Notice of Decision

Site Plan Review

Files: **SP-28-19 & FP-09-19**

Proposal:	Site Plan Review and Floodplain Development Review to construct a 264-unit apartment complex (Brandis Meadows Apartments) with associated parking and common open space.
Review Body:	Staff (Type I-L review)
Property Owner:	Brandis Village, LLC PO Box 3308, Salem, OR 97302
Applicant:	Montagne Development Group, LLC PO Box 3308, Salem, OR 97302
Engineer:	Mark Grenz; Multi/Tech Engineering, Inc. 1155 13th Street SE, Salem, OR 97302
Representative:	Brandie Dalton; Multi/Tech Engineering, Inc. 1155 13th Street SE, Salem, OR 97302
Address/Location	4350 Knox Butte Road SE, Albany, OR 97321
Map/Tax Lot:	Linn County Assessor's Map No. 11S-03W-03C; Tax Lot 100
Zoning:	MUC (Mixed Use Commercial), OS (Open Space), /FP (Floodplain Overlay), /SW (Significant Wetland Overlay) and /RC (Riparian Corridor Overlay) Districts
Comprehensive Plan	Village Center and Open Space

PRELIMINARY SITE PLAN

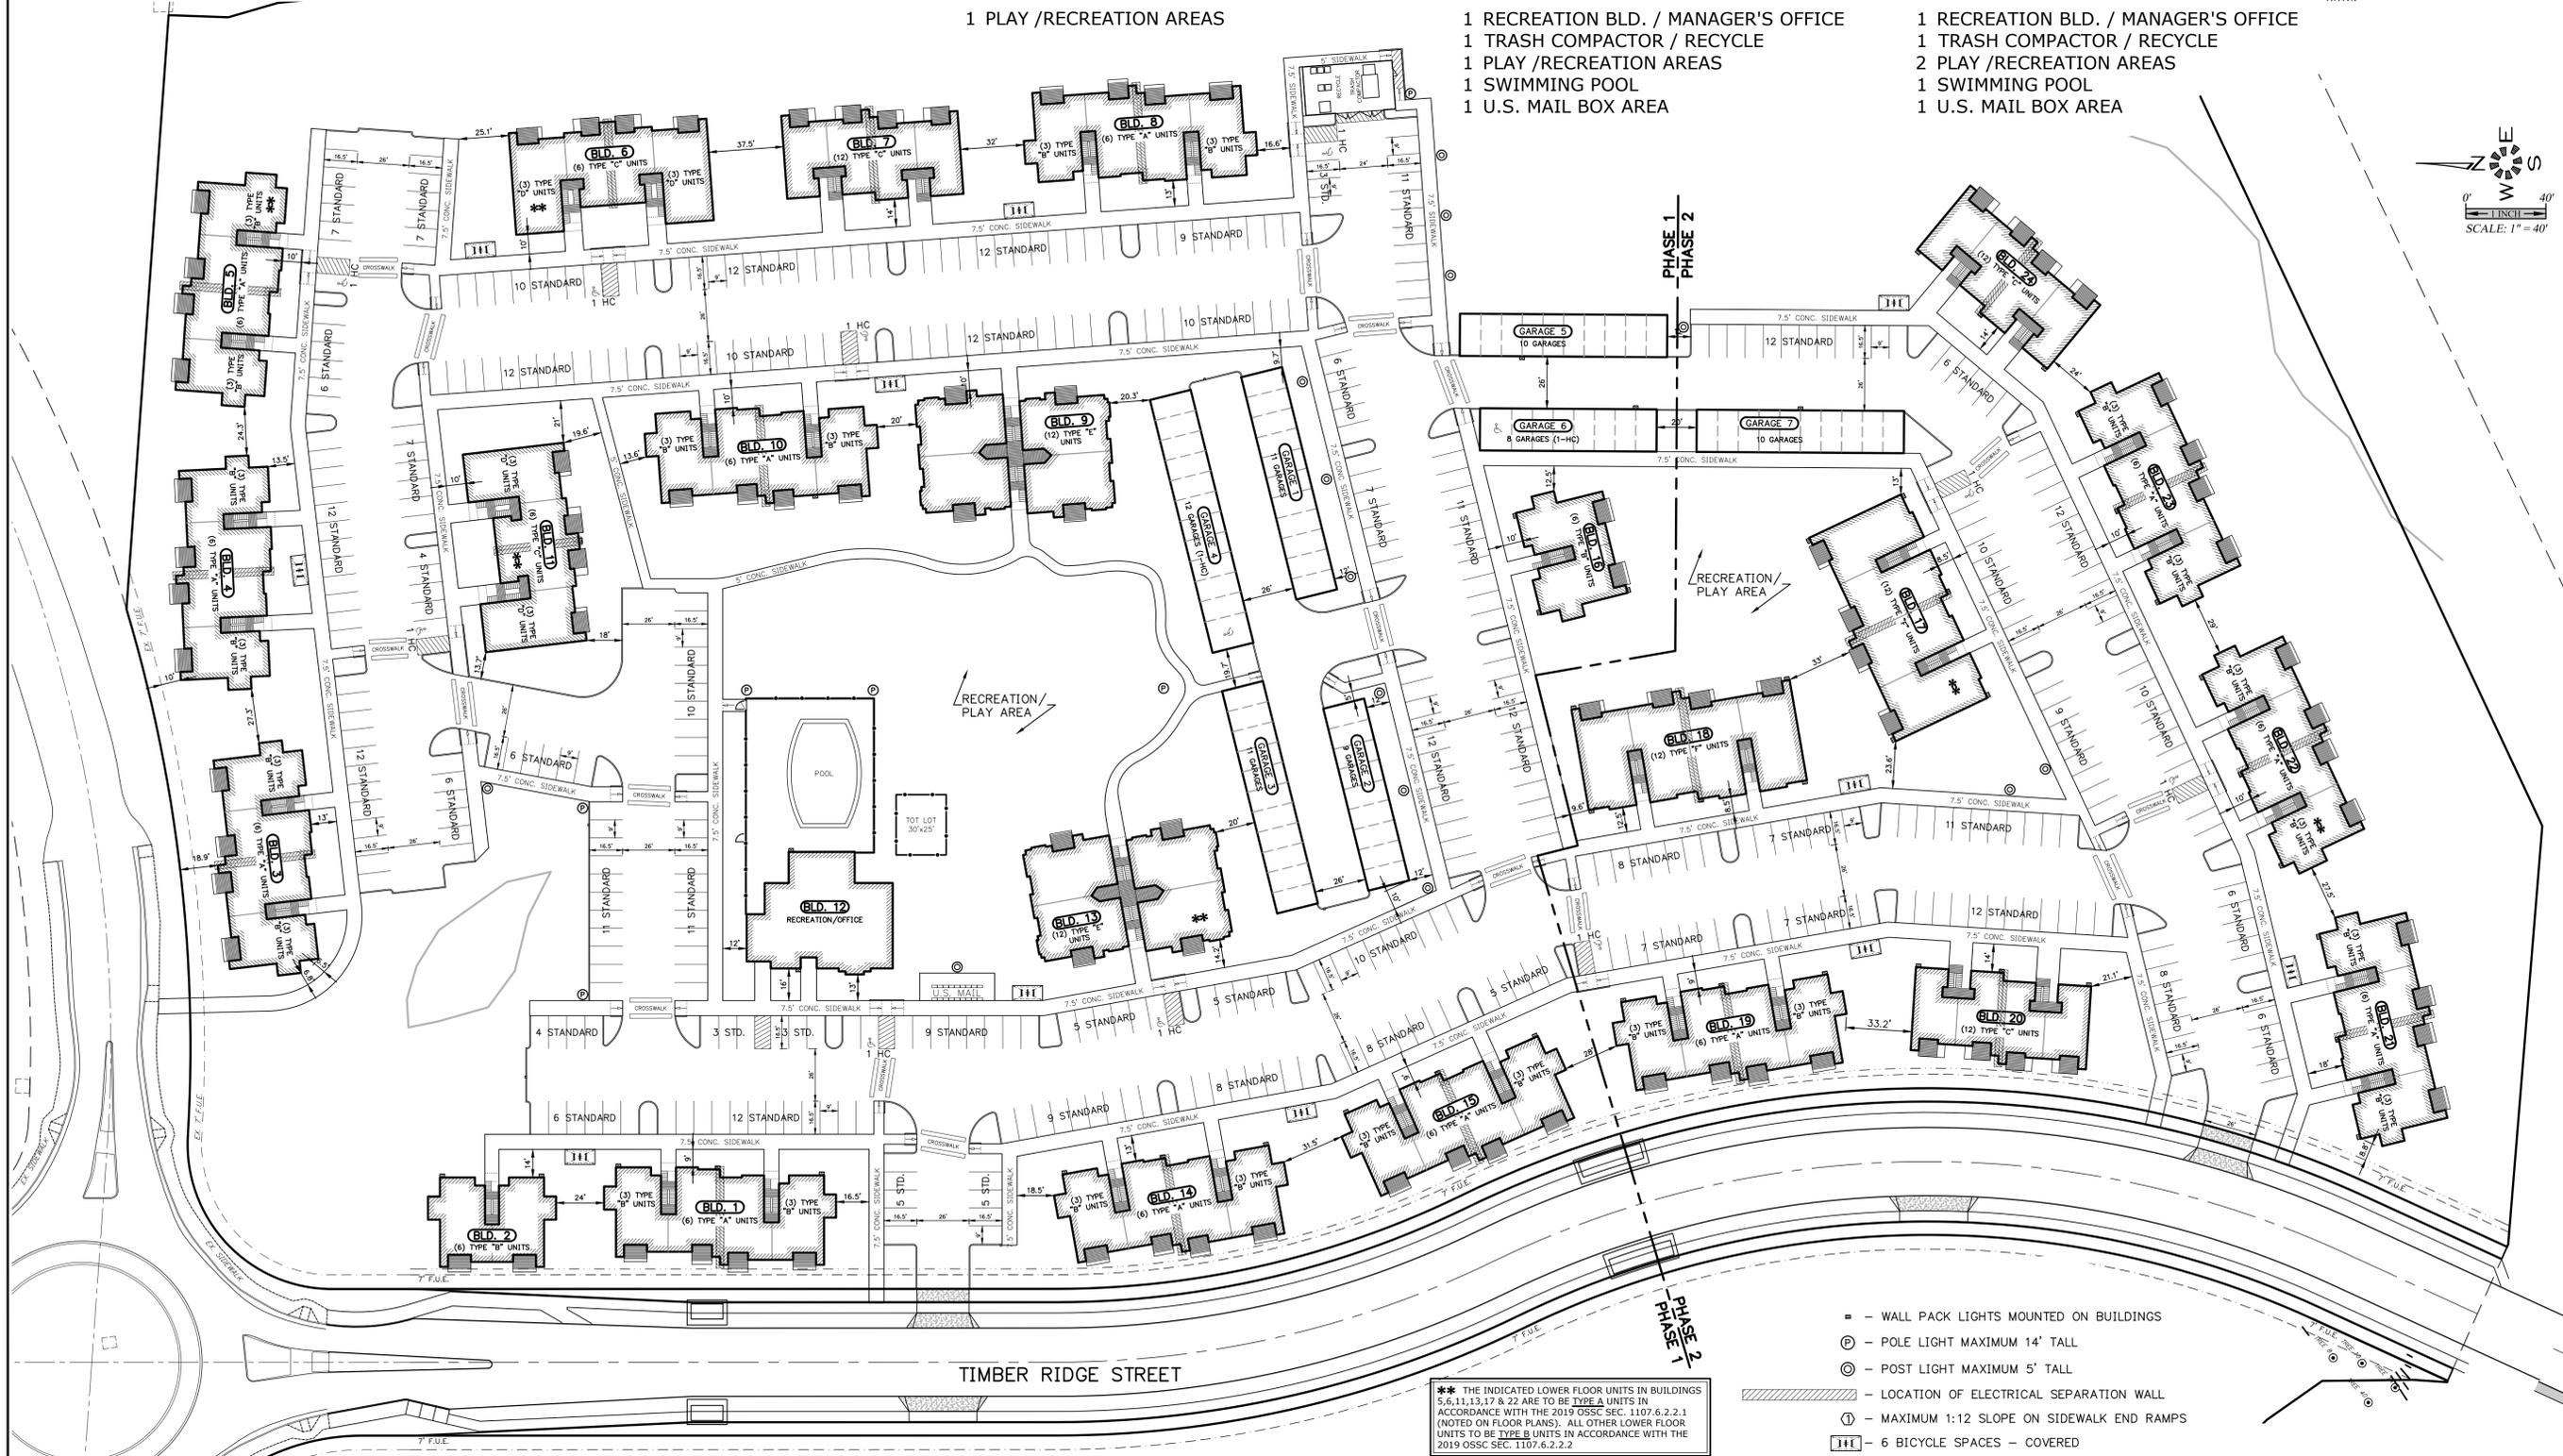
- Condition 9** Prior to issuance of a building permit, the applicant shall submit a revised site plan to the Community Development Department for review and approval, to meet the five-foot dead-end backup area requirement, consistent with the standards of Table 9-2: Parking Lot Design and Supplemental Drawings.

- Condition 16** Prior to issuance of a building permit, the applicant shall submit a revised site plan to the Community Development Department for review and approval that includes:

- At-grade patios at least 96 square feet, with no dimension less than 8 feet and screened from view from public streets per ADC 8.230(1).
 - Above-grade patios at least 80 square feet, with no dimension less than 6 feet per ADC 8.230(1).

- Two additional pedestrian connections, one on the north of Building 2, and one between Buildings 15 and 19 to meet the standard under ADC 8.280(3).
 - Children's play area/tot lot to include play equipment to function as a children's play area.
